PLANNING REPORT

Bridge Park, Block J – Administrative Departures 25-055FDP

25-055FDP - Bridge Park, Block J

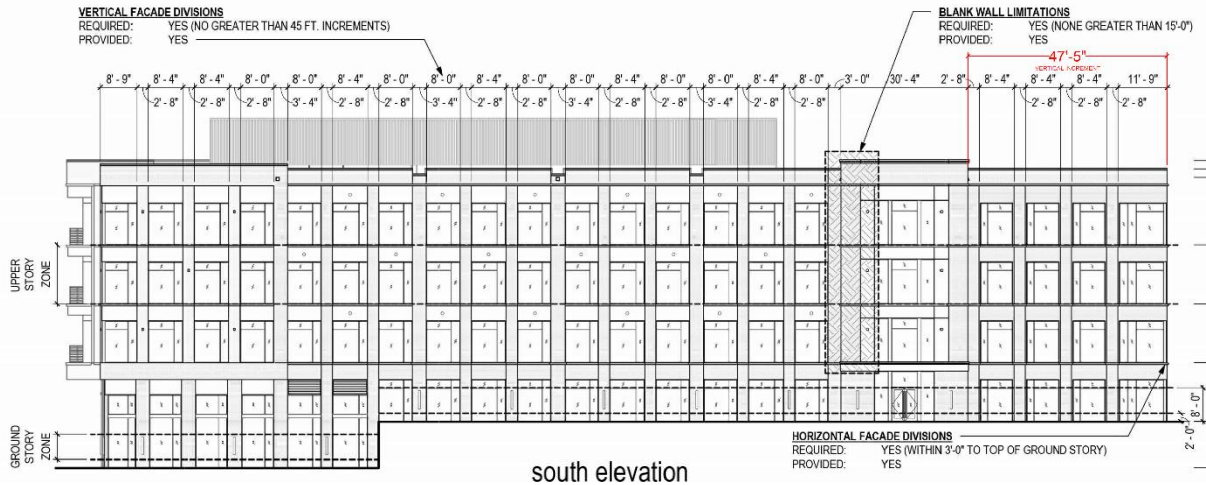
2. 153.062(O)(6)(d)(4) – Required Change in the Roof Plane: The applicant is requesting approximately 83 feet of continuous roof plane at the northwest corner of the building. This section of the building highlights the intersection of Bridge Park Avenue and Dale Drive but exceeds the 80-foot requirement for a break along the roof plane.

Administrative Departure: 153.062(O)(6)(d)(4) – Required Change in the Roof Plane

Requirement: No greater than 80 ft

Request: To allow approximately 83 feet of continuous roof plane at the northwest corner of the building.

Criterion Met: The AD is caused by the desire to create distinct massing at the northwest corner of the building to address the intersection of Bridge Park Avenue and Dale Drive, while also responding to a change in grade. It is consistent with the intent of the applicable plans and code requirements.

Criterion Met: The requested AD is a design choice that does not affect cost or provide general convenience.

Criterion Met: The AD does not affect uses, signs or building/open space types.

Criterion Met: The AD does not change the pedestrian experience.

Criterion Met: The AD will help better address the street intersection and change in grade.

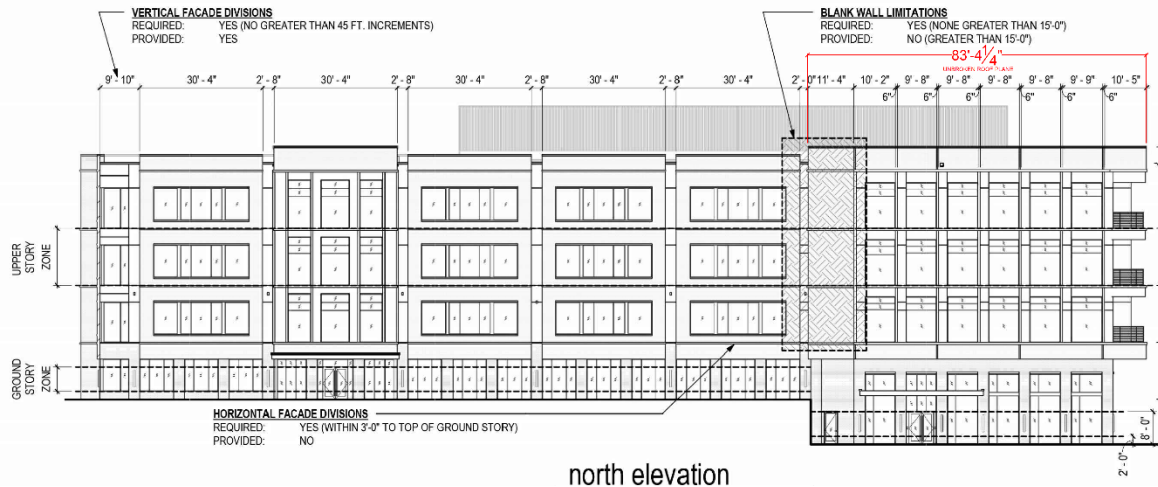
1. 153.062(O)(6)(d)(4) – Façade Divisions – Vertical Increments Required: The applicant is requesting an approximately 47-foot vertical increment of the façade on the south elevation. Although the façade has material breaks, portions of the façade do not create a physical break in the southern façade.

Administrative Departure: 153.062(O)(6)(d)(4) – Façade Divisions – Vertical Increments Required

Requirement: No greater than 45 feet

Request: To allow an approximately 47-foot vertical increment on the south elevation.

Considerations	Review
1. The need for the AD is caused by unique site conditions, conditions on surrounding properties, and/or otherwise complies with the spirit and intent of the Community Plan, BSD Special Area Plan, BSD Design Guidelines, other adopted city plans and policies, and all applicable requirements within 153.057 through 153.066;	Criterion Met: The AD is caused by the desire to maintain a consistent design rhythm around the eastern portion of the south façade. It is consistent with the intent of the applicable plans and code requirements.

2. The AD is not being requested simply to reduce cost or as a matter of general convenience;	Criterion Met: The requested AD is a design choice that does not affect cost or provide general convenience.

3. The AD does not have the effect of authorizing any use, sign, building type, or open space type that is not otherwise permitted in the BSD district;	Criterion Met: The AD does not affect uses, signs or building/open space types.

4. The AD, if approved, does not adversely impact the pedestrian experience; and	Criterion Met: The AD does not change the pedestrian experience.
5. The AD, if approved, will ensure that the development is of equal or greater development quality with respect to design, material, and other development features than without the AD.	Criterion Met: The proposed design maintains design consistency around the eastern portion of the south façade.
